ADDENDUM NUMBER ONE
CHATTANOOGA PUBLIC LIBRARY – CHILLER AND BOILER IMPROVEMENTS
CONTRACT NO. L-18-001
JANUARY 25, 2019
CITY OF CHATTANOOGA, TENNESSEE

The following changes shall be made to the Request for Bids:

Public Library Chiller and Boiler Improvements

Title:
**Housekeeping Pad
Details**

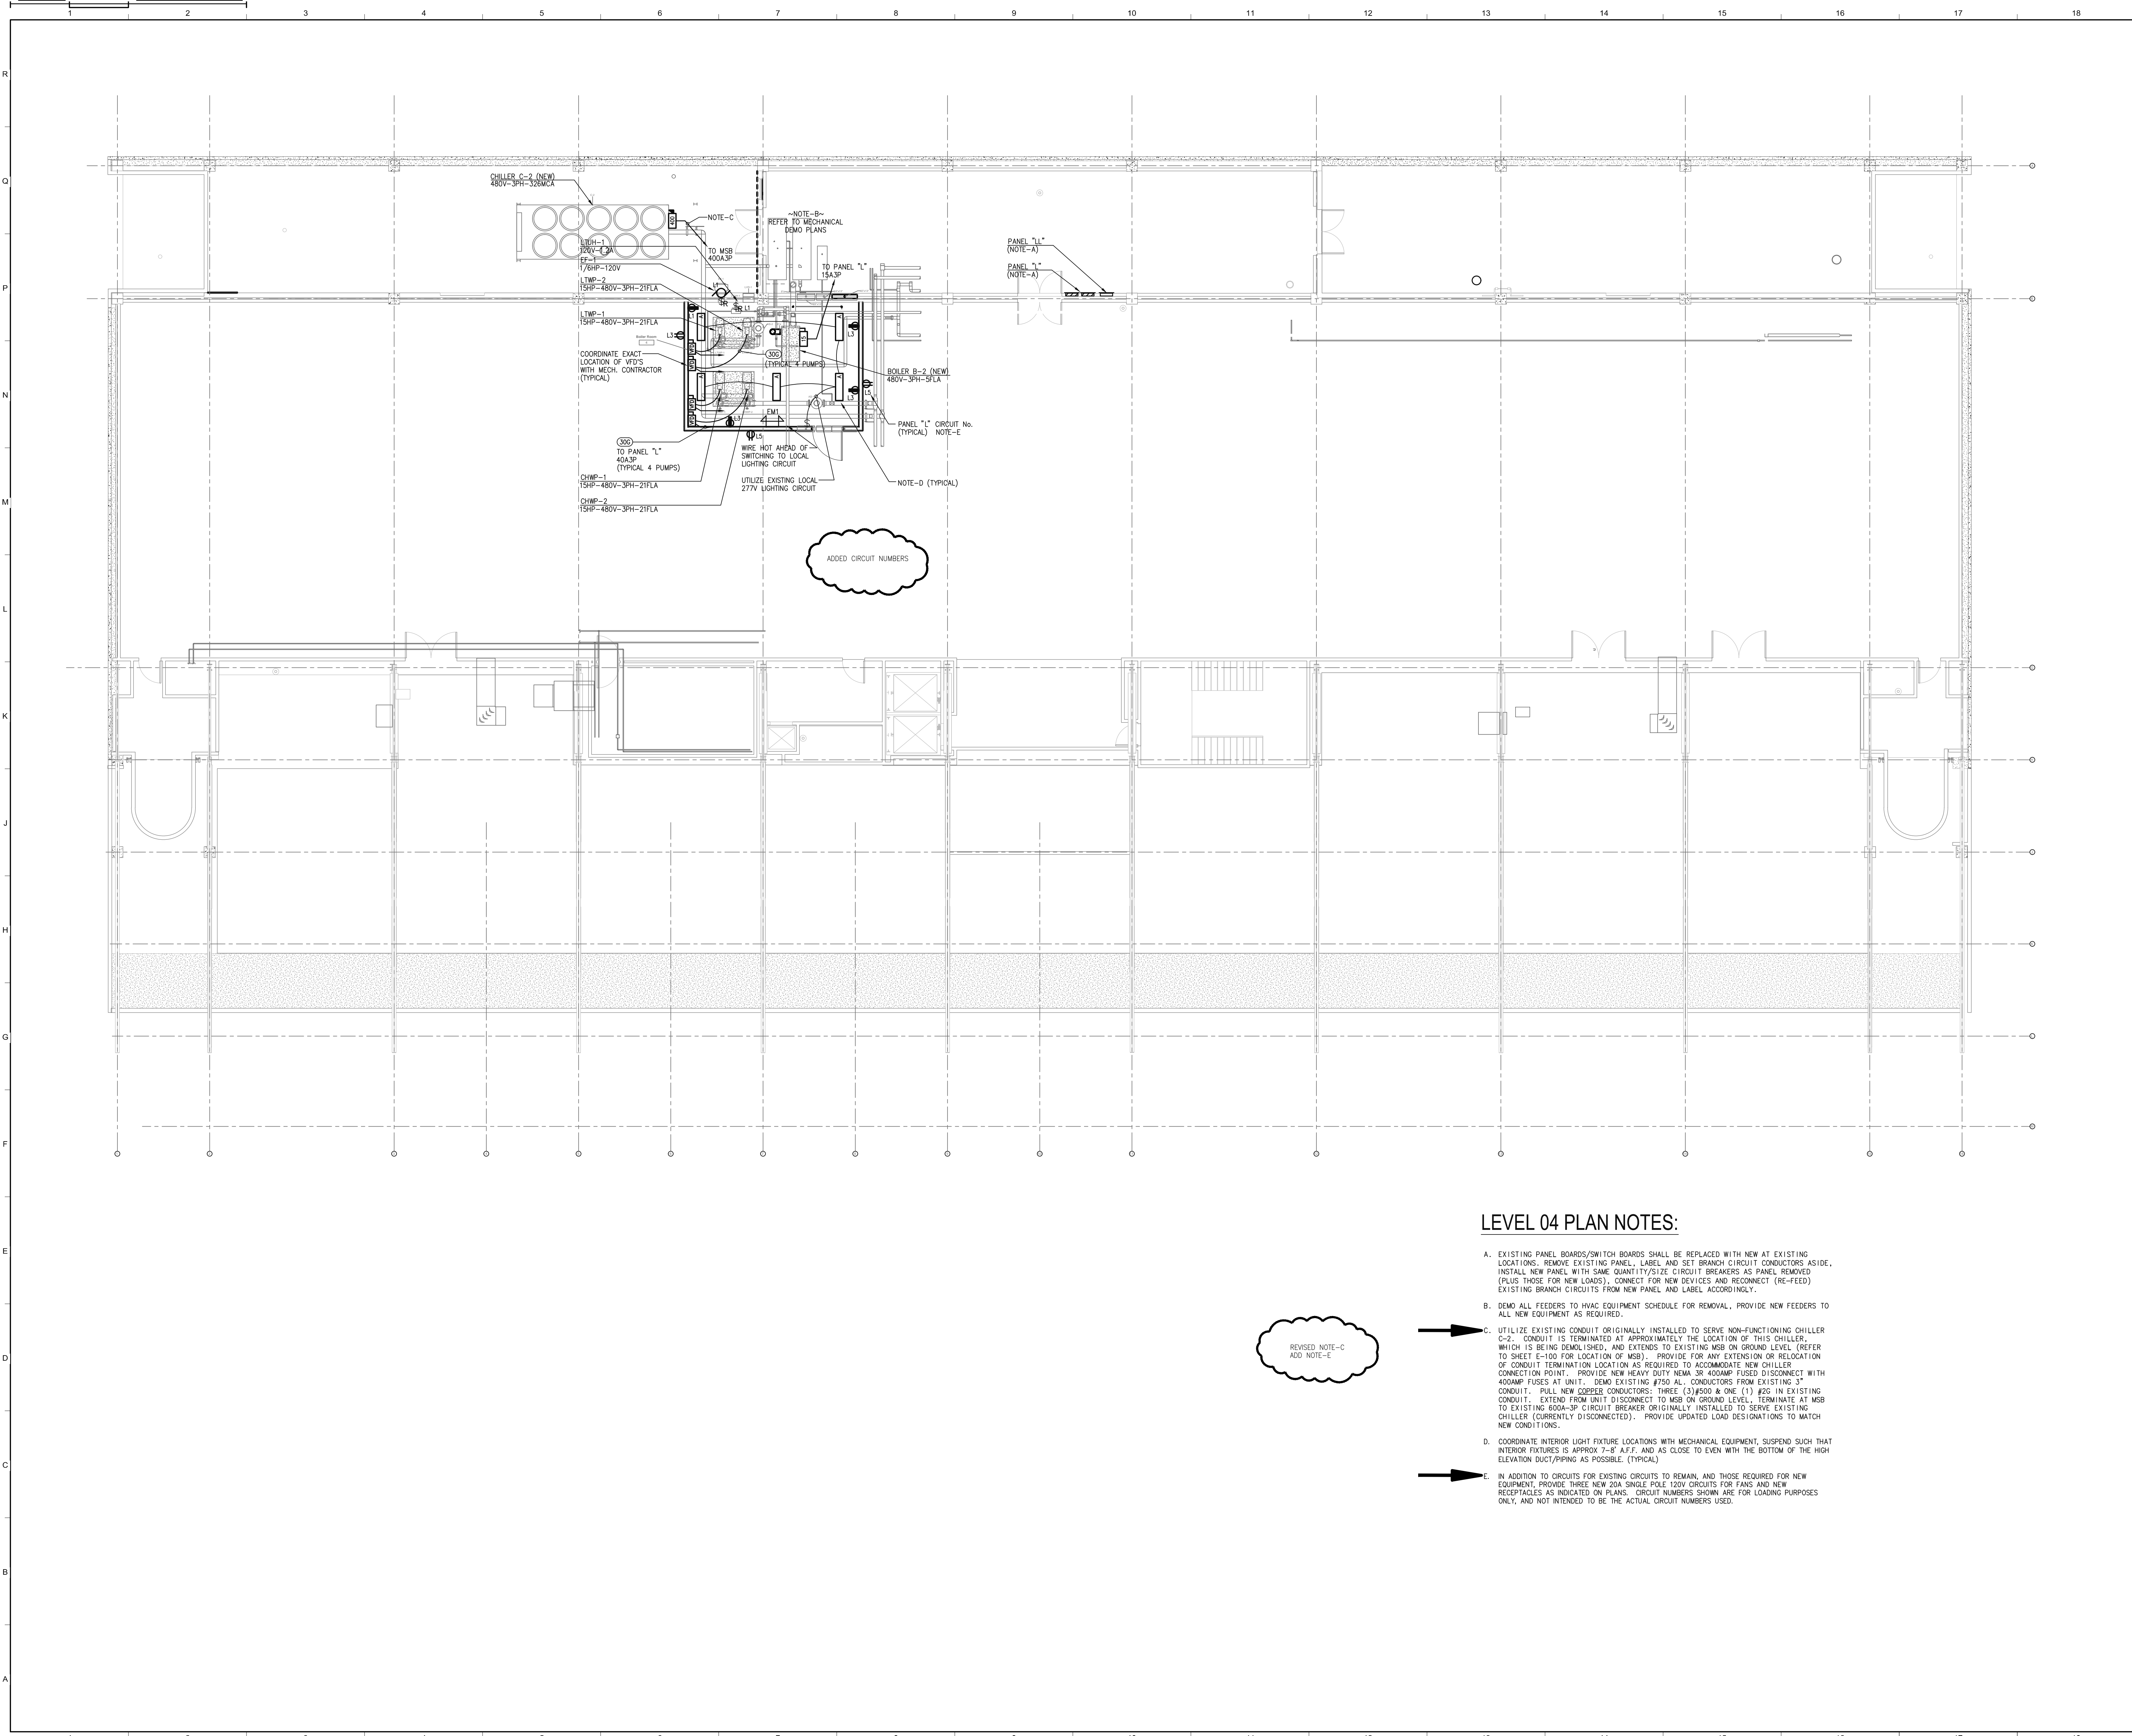
- c. Sheet A-342 Housekeeping Pad Details (new sheet) is issued as part of this addendum and indicates details of the housekeeping pads.
- d. Sheet M-206 HVAC Piping Boiler / Chiller is re-issued as part of this addendum and describes changes to the housekeeping pads and piping locations.

Title:
**ELECTRICAL PLAN-
FOURTH FLOOR**

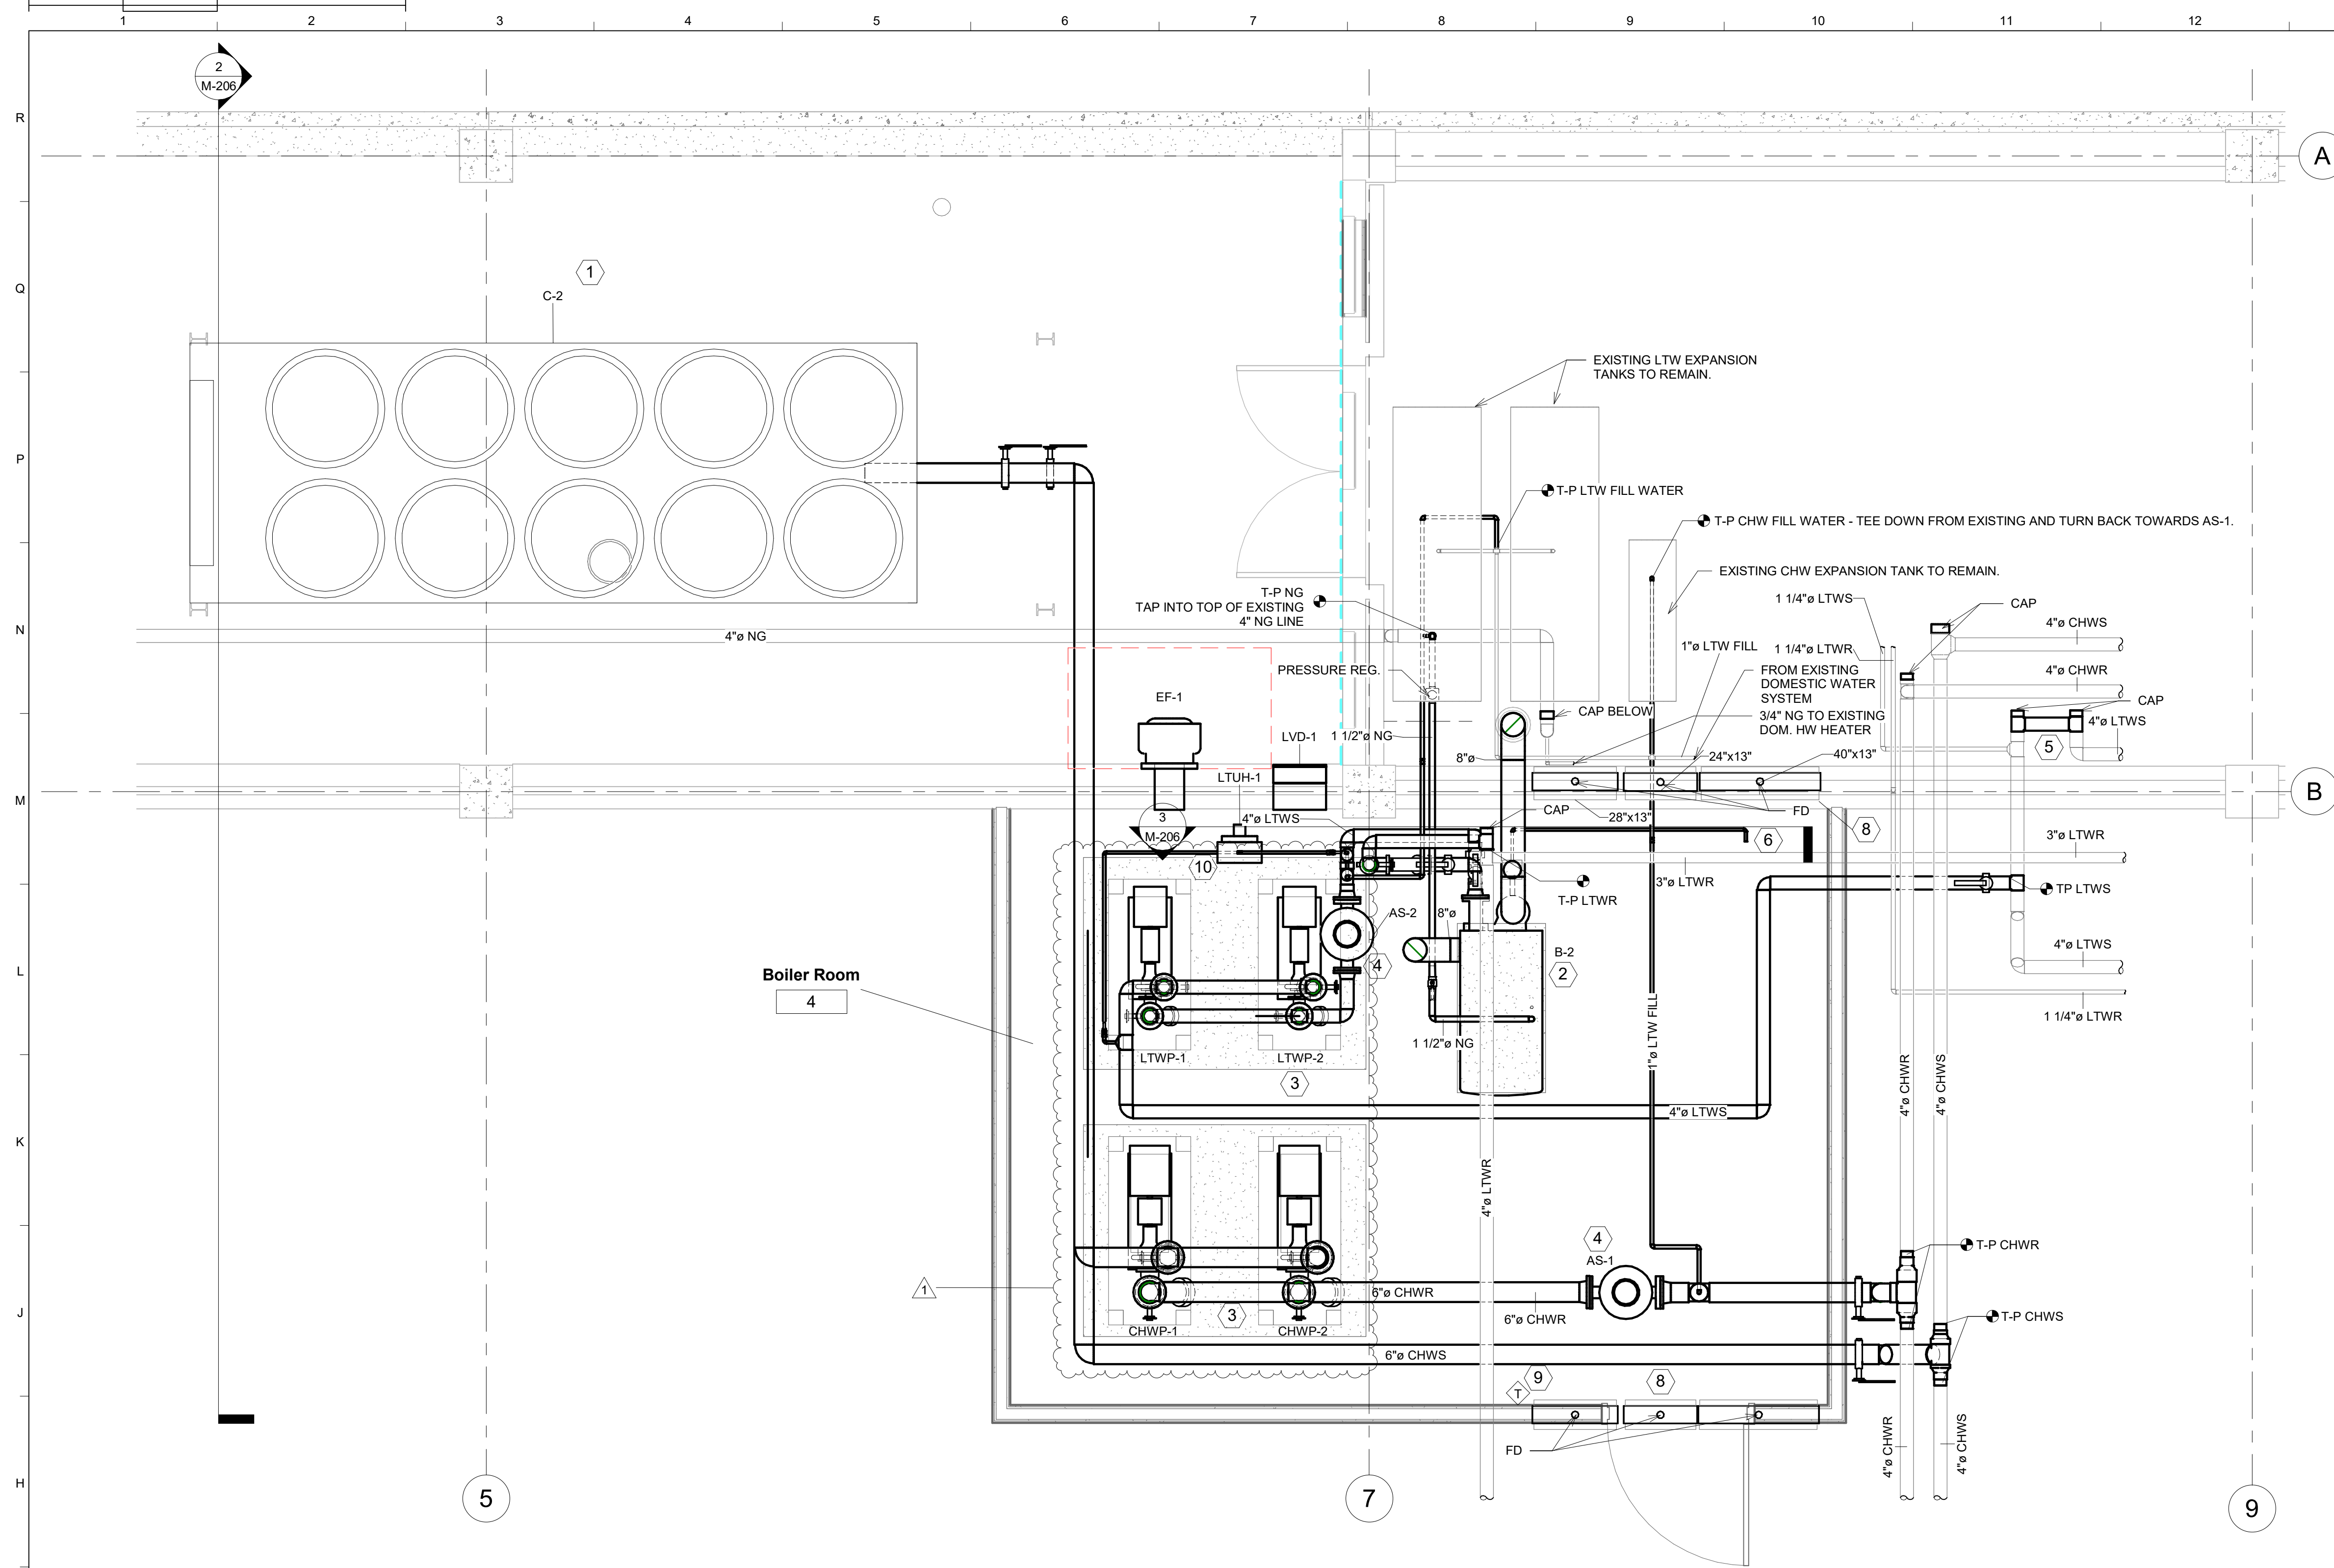
- g. Sheet MD-205 HVAC Piping Demo – Boiler/Chiller is re-issued as part of this addendum and lists changes described in this addendum.
- h. Sheet E-104 Electrical Plan-Fourth Floor is re-issued as part of this addendum and adds circuits and receptacles in boiler room and modifies main feed to Basement switchgear.

REVISED NOTE-C
ADD NOTE-E

- B. DEMO ALL FEEDERS TO HVAC EQUIPMENT SCHEDULE FOR REMOVAL. PROVIDE NEW FEEDERS TO ALL NEW EQUIPMENT AS REQUIRED.
- C. UTILIZE EXISTING CONDUIT ORIGINALLY INSTALLED TO SERVE NON-FUNCTIONING CHILLER C-2. CONDUIT IS TERMINATED AT APPROXIMATELY THE LOCATION OF THIS CHILLER, WHICH IS BEING DEMOLISHED, AND EXTENDS TO EXISTING MSB ON GROUND LEVEL. (REFER TO SHEET E-100 FOR LOCATION OF MSB). PROVIDE FOR ANY EXTENSION OR RELOCATION OF CONDUIT TERMINATION LOCATION AS REQUIRED TO ACCOMMODATE NEW CHILLER CONNECTION POINT. PROVIDE NEW HEAVY DUTY NEMA 3R 400AMP FUSED DISCONNECT WITH 400AMP FUSES AT UNIT. DEMO EXISTING #750 AL. CONDUCTORS FROM EXISTING 3" CONDUIT. PULL NEW COPPER CONDUCTORS: THREE (3) #500 & ONE (1) #250 IN EXISTING CONDUIT. EXTEND FROM UNIT DISCONNECT TO MSB ON GROUND LEVEL. TERMINATE AT MSB TO EXISTING 600A-3P CIRCUIT BREAKER ORIGINALLY INSTALLED TO SERVE EXISTING CHILLER (CURRENTLY DISCONNECTED). PROVIDE UPDATED LOAD DESIGNATIONS TO MATCH NEW CONDITIONS.

- E. IN ADDITION TO CIRCUITS FOR EXISTING CIRCUITS TO REMAIN, AND THOSE REQUIRED FOR NEW EQUIPMENT, PROVIDE THREE NEW 20A SINGLE POLE 120V CIRCUITS FOR FANS AND NEW RECEPTACLES AS INDICATED ON PLANS. CIRCUIT NUMBERS SHOWN ARE FOR LOADING PURPOSES ONLY, AND NOT INTENDED TO BE THE ACTUAL CIRCUIT NUMBERS USED.
